# Heritage Response to Consultee Comments, 28 Albert Street, Camden

## APPN 2023/1541/L & APPN 2023/0849/P

This note has been prepared in response to the consultation comments raised by the Conservation Officer and by the 20<sup>th</sup> Century Society and Camden Town Conservation Area Advisory Group, which relate specifically to the proposed works to the rear extension at 28 Albert Street.

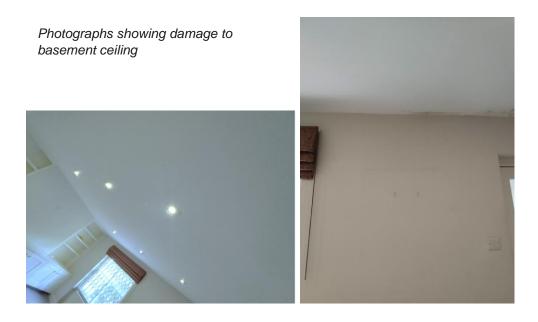
**DAMAGE TO HISTORICAL FABRIC**: The party wall in the stairwell suffered similarly from heavy waterdamage. The recently added wallpaper of the previous owner was peeling, bubbling and extensively discoloured. When the wallpaper was removed, the plaster crumbled down to the original brickwork. This is a result of damp and it is worth noting that 30 Albert St., the neighbouring property's party wall in the basement has been stripped down to the brickwork and is currently being treated for damp. This property is being managed by Camden Council and the Council is overseeing all work that is being performed. We however did not intend for the brick work in 28 Albert St to be exposed and we will refinish it in a lime plaster in order to restore it.
